RV1806000
Kiddo Lenox Ave
BC1704556

GROUND FLOOR KEY PLAN
"REVIEWED and APPROVED FOR CODE COMPLIANCE"
MAR 30 2018
NOVA ENGINEERING and ENVIRONMENTAL LLC
MIAMI BEACH FIRE DEPARTMENT
3-30-2018 OWNER CHANGES: REVISED DOOR SWING, REVISED ANY CLOSET

NEW RESTAURANT FOR:
CHOTTO MATTE LTD.
1666 LENOX AVE. MIAMI BEACH, FL 33139

PROPOSED EQUIPMENT PLAN

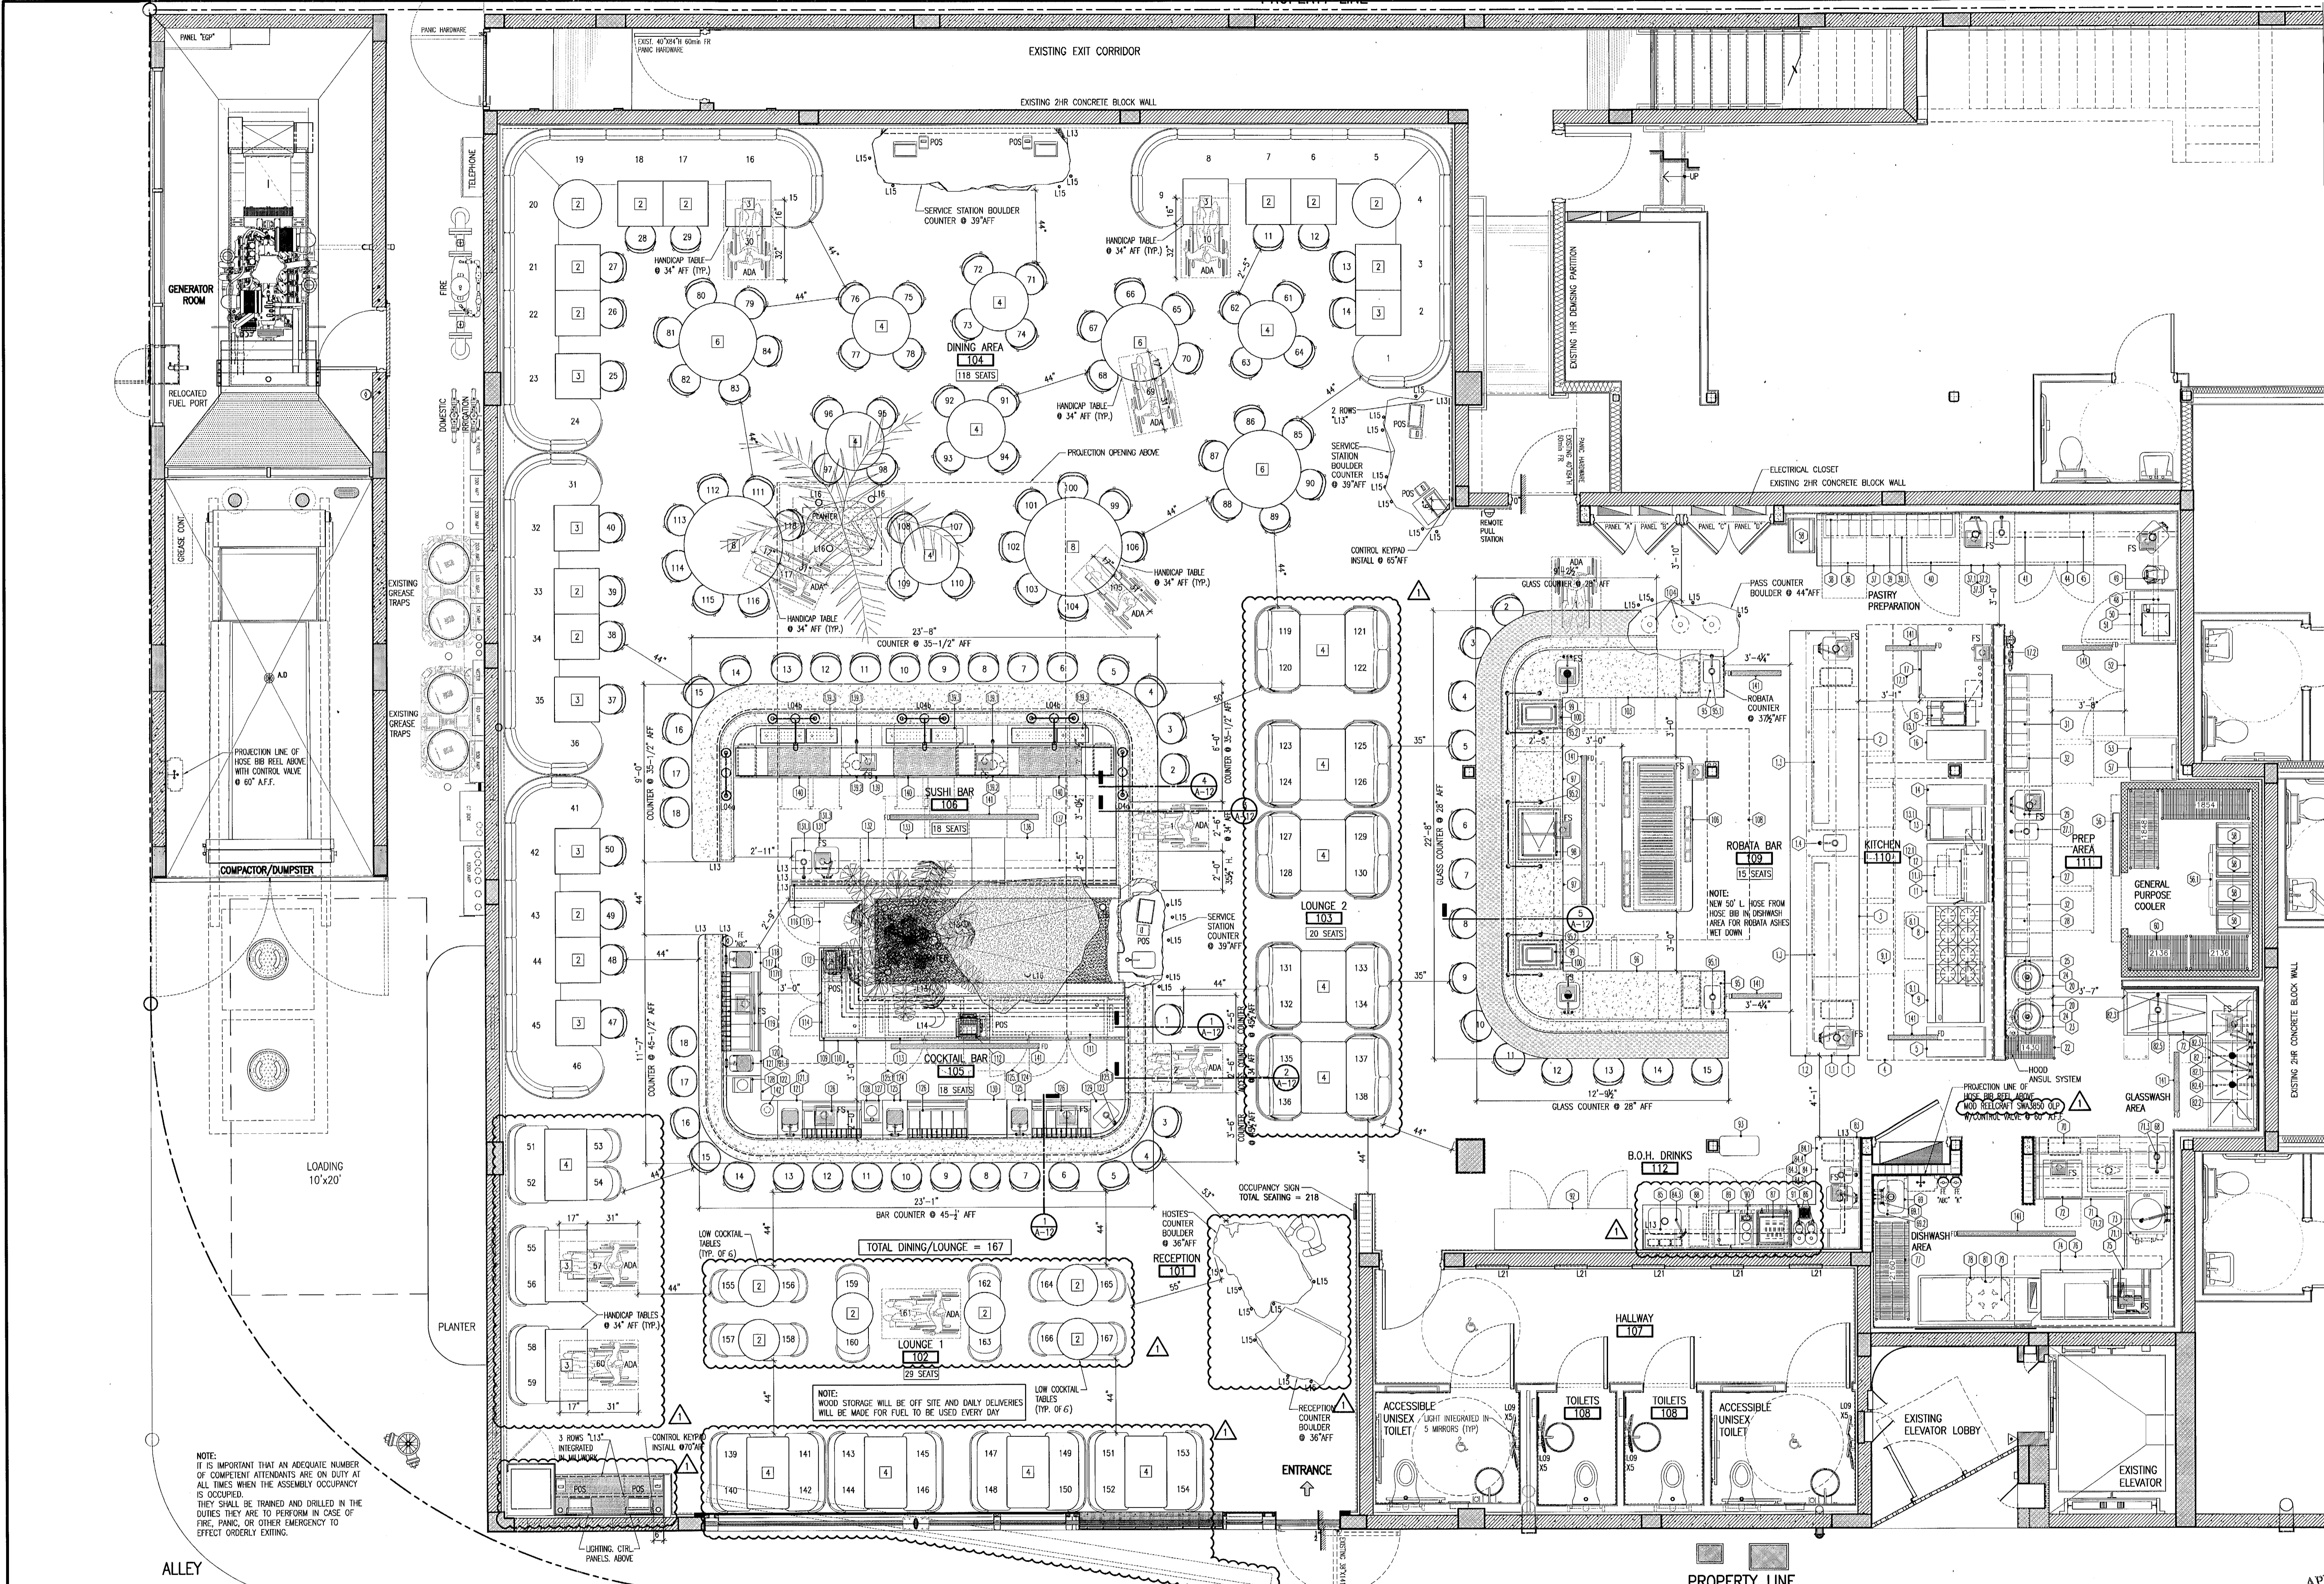
APPROVED 3-30-2018 OWNER CHANGES: REVISED EQUIPMENT AT BEVERAGE AREA, REVISED FURNITURE LAYOUT, REEL MODEL NUMBER ADDED
